Cumberland County Subdivision and Land Development Review Report

Municipality:	<u>North Middleton</u>	Surveyor/ Engineer:	<u>Alpha Consulting Engineers, Inc.</u>	Owner/ Developer:	<u>Gettys Ventures</u>
Plat Title:	<u>Village at North Ridge - Phase 4</u>				
Plat Status:	<u>Final</u>	Plat Type:	<u>Subdivision</u>		
# of New Lots:	<u>22</u>	# of New Dwelling Units:	<u>20</u>	New Acreage Subdivided/Developed:	<u>5.7</u>
				Total Tract Acreage:	<u>5.7</u>
Zoning District:	<u>R-1</u>	Proposed Land Use:	<u>Residential Duplex</u>		
Date Received:	<u>1/3/2020</u>	County Review:	<u>1/23/2020</u>	Reviewed by:	<u>EG</u>
				Checked by:	<u>SH</u>

FINAL SUBDIVISION PLAN FOR THE VILLAGE AT NORTH RIDGE - PHASE 4

PHASING DIAGRAM

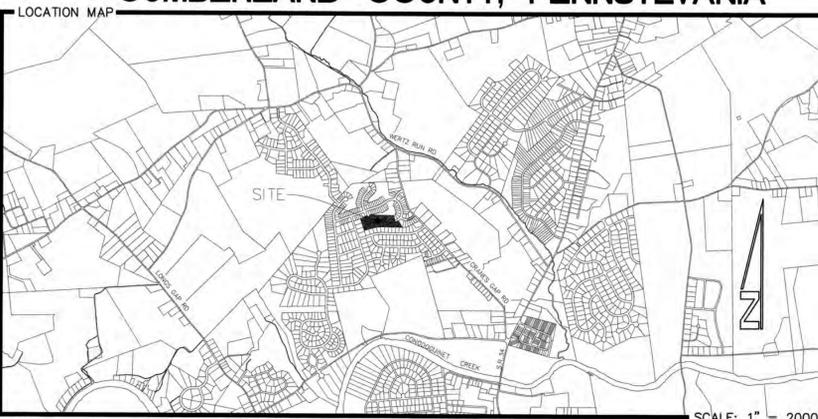
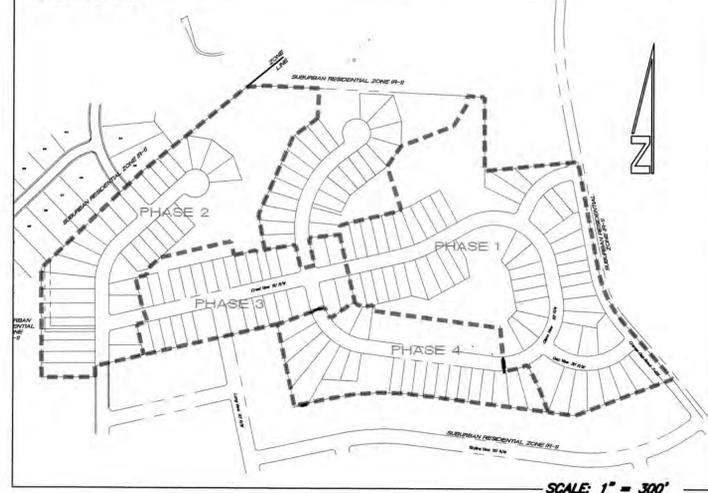
2. A graphic scale should be included on the Phasing Diagram and the Location Map (SALDO 180-24.B.4).
3. A time schedule indicating when each phase is to be completed should be indicated on the plan (SALDO 180-24.B.10).
